Planning, Land Use and Mobility Committee

Case Report: **DIR 2018-3324-SPP**
 6622 -6636 N. Variel Ave.
 6617-6635 N. Independence
 Woodland Hills, CA 91367

WHWCNC First: August 16, 2018
PLUM Meetings: Second: October 4, 2018
 Third: November 1, 2018
 Fourth: December 6, 2018

Renderings of Prior Stoop Version (left) and the First New Version (right) along Kittridge.

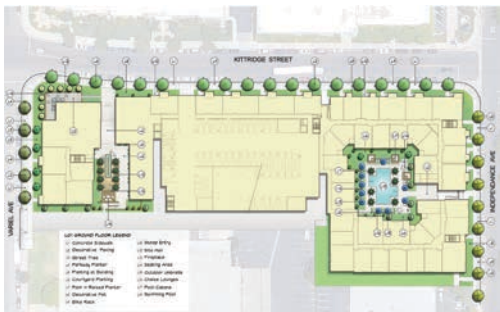
- The third presentation (November 1st) gave increased detailing of the stoops along Kittridge in response to the committee’s suggestions that they offer variety and detailing of interest to pedestrians. The committee expressed reservations that the design offered hiding places for transients. The latest design (December 6th) offers semi-transparent grills, which riff on the art designs of the plaza artwork and gates. The applicant agreed that low gates at the foot of the steps would help.

Original Site plan and general Landscaping

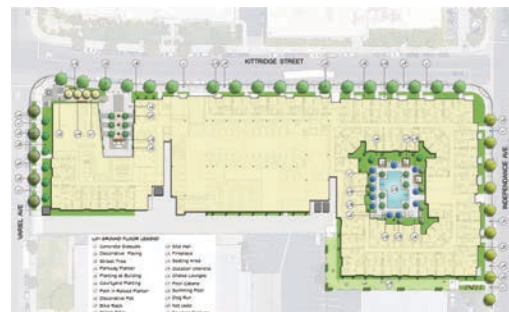
The original application plans do not list existing trees, but does propose 99 trees as required (1 per 4 units). Those plans claimed to landscape 56% of the publicly accessible open space. Street frontages will have landscape buffers. There are small amounts of landscaping on the southern edges of the project including a dog run.

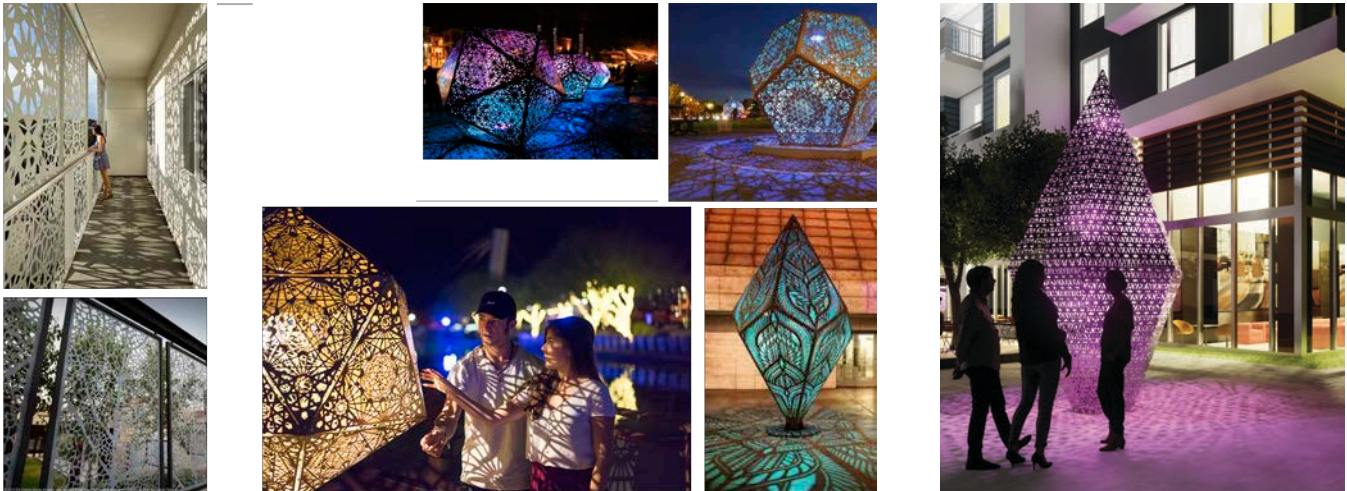
- Initially, every member of the committee complained about the treatment of the parking structure with suggestions that it needed embellishment.

At the second presentation (October 4th), vertical elements via landscaping and architectural elements (screening panels) were added to break up the long horizontal lines of the ramped floors. Committee comments suggested further refinement of the repetitive panels for more variety.

At the third presentation (November 1st) the project plans showed better variety to the panels. Taller vegetation, either trees or vining, was requested between panels to further shade the structure. The committee was still not overly satisfied.

In addition to retaining the landscaping, the fourth presentation (December 6th) offered a new design with one large frame surrounding numerous 3-dimensional crystalline objects with 2 options of colored panels. The committee felt the new offering was not satisfactory and that the prior design would be better if it morphed into trapezoidal shapes that related to the artwork on the front part of the project. The applicant agreed to present a refined version for the Board.
